APPROVAL SOUGHT:

Master Plan Zoning Amendment to an existing Zoning approval to allow the utilization of individual wells and septic systems rather than County Water and City Sewer and Preliminary and Final Plat and Development Plan approval to create four (4) commercial lots on a 34.44 ± acre parcel to be utilized for Commercial/Industrial use.

RIO SANTA FE BUSINESS PARK PRELIMINARY & FINAL SUBDIVISION PLAT & AMENDED MASTER PLAN

Re: CDRC Case # MPA/PP/FP/FDP 10-5352 Rio Santa Fe Business Park- Master Plan, Preliminary and Final Plat T16N, R8E, Sec 2, 3 and 10.

AMENDED MASTER PLAN

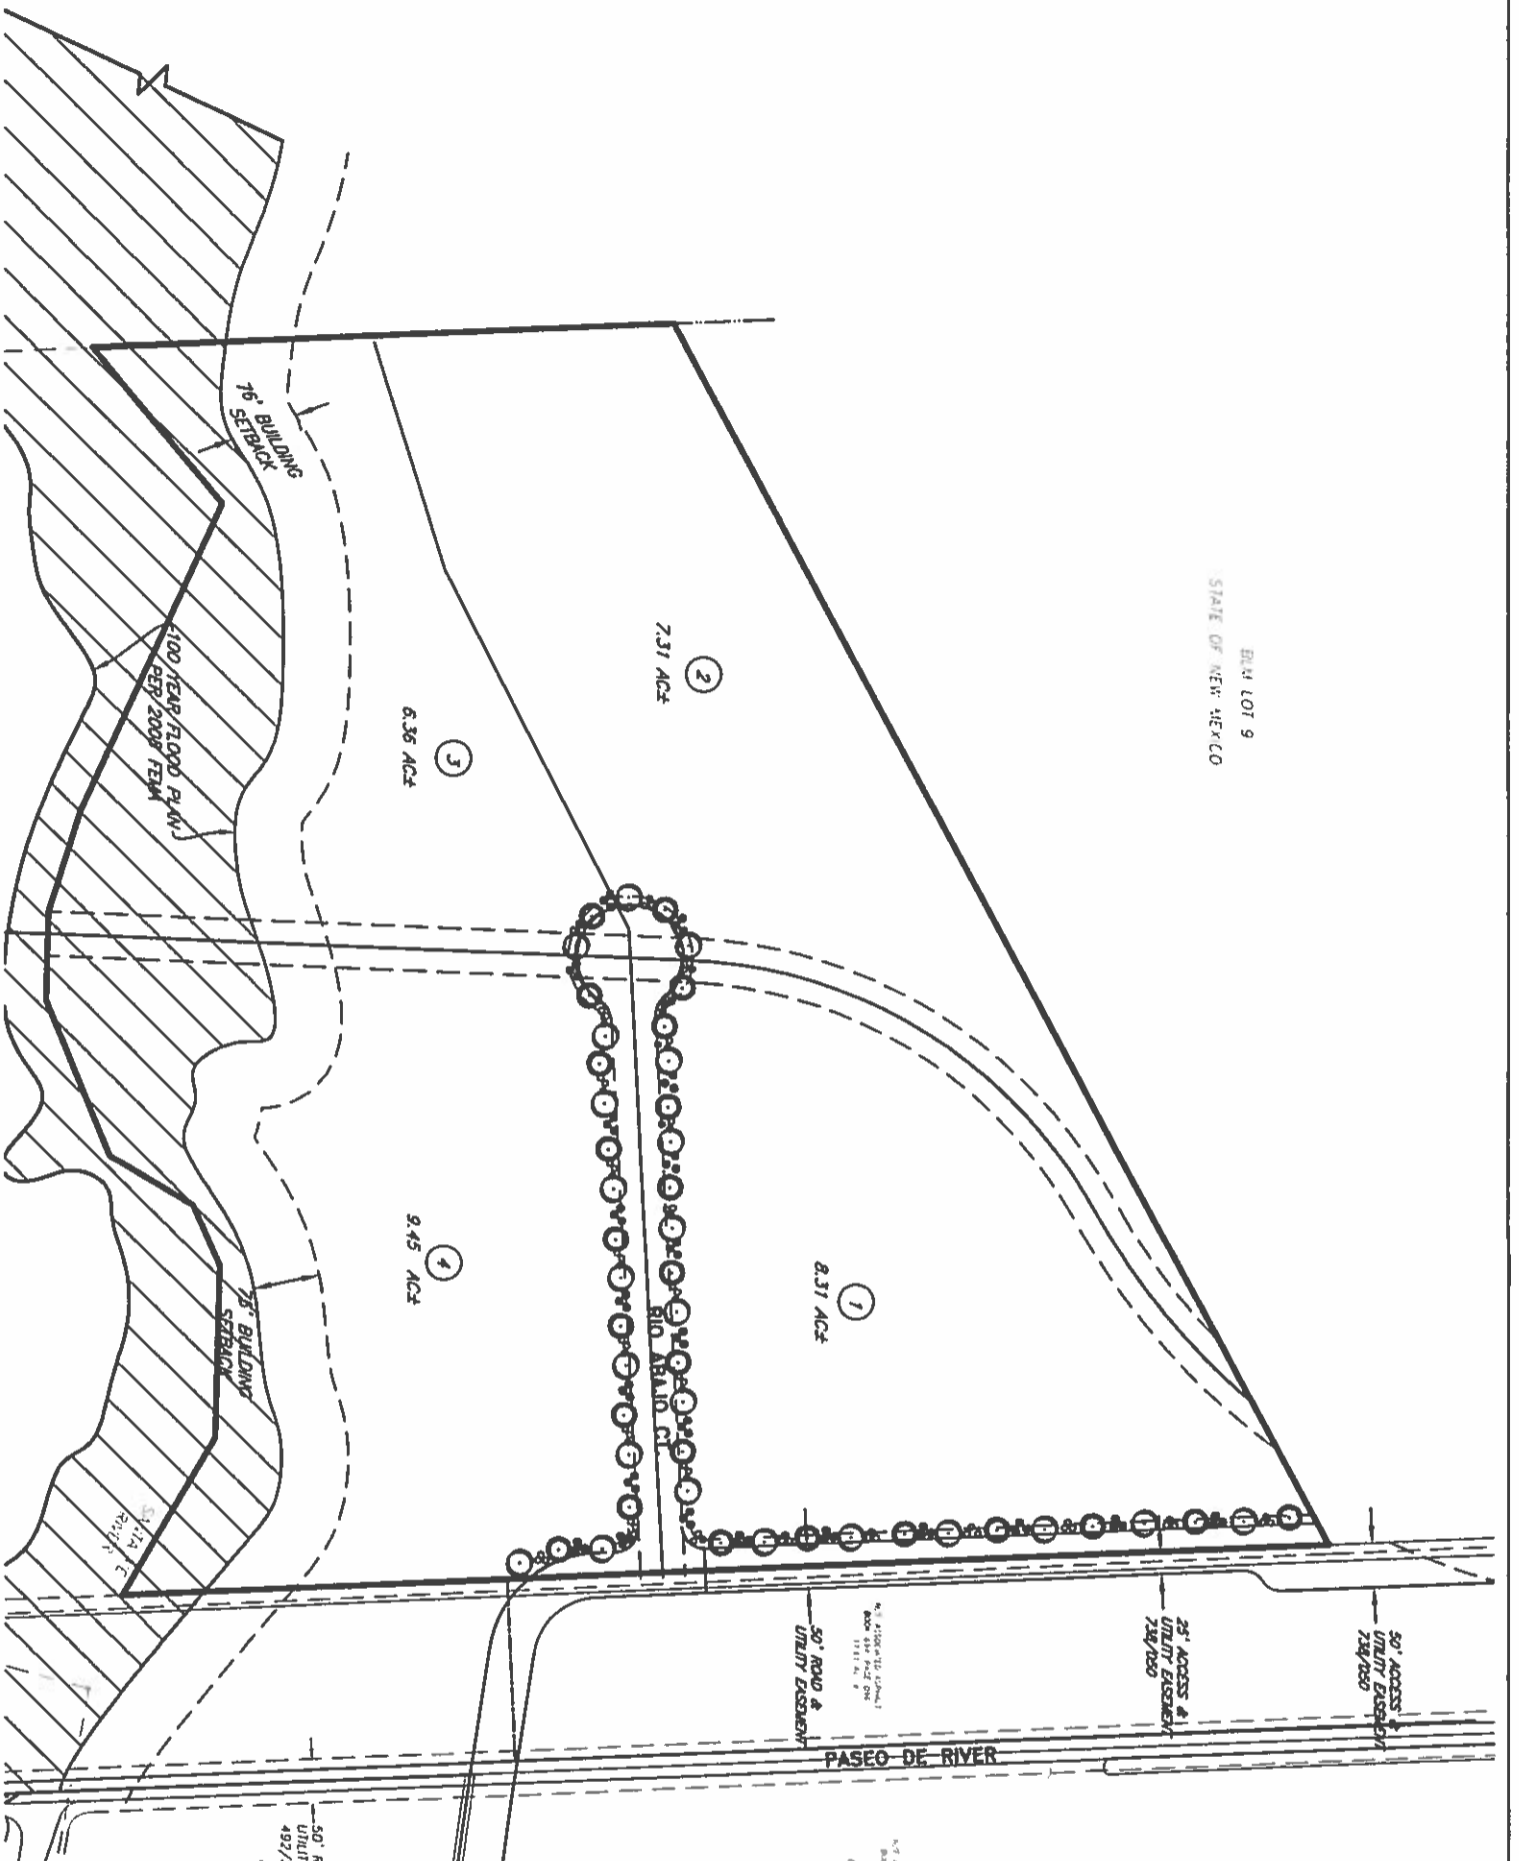
1. Change Item 2 under Notes and Conditions on sheet P-4 to read "Water use is restricted to 0.25 acre-feet per lot per year unless the lot owner prepares a geohydrologic report approved by the County Hydrologist demonstrating water availability as allowed by the code."
2. Include the statement "Submission of a water quality documentation package pursuant to Article VII Section 6.5.1d upon drilling of a well to serve any future development" on the final plat in addition to the disclosure statement.
3. Submission of water restrictive covenants.
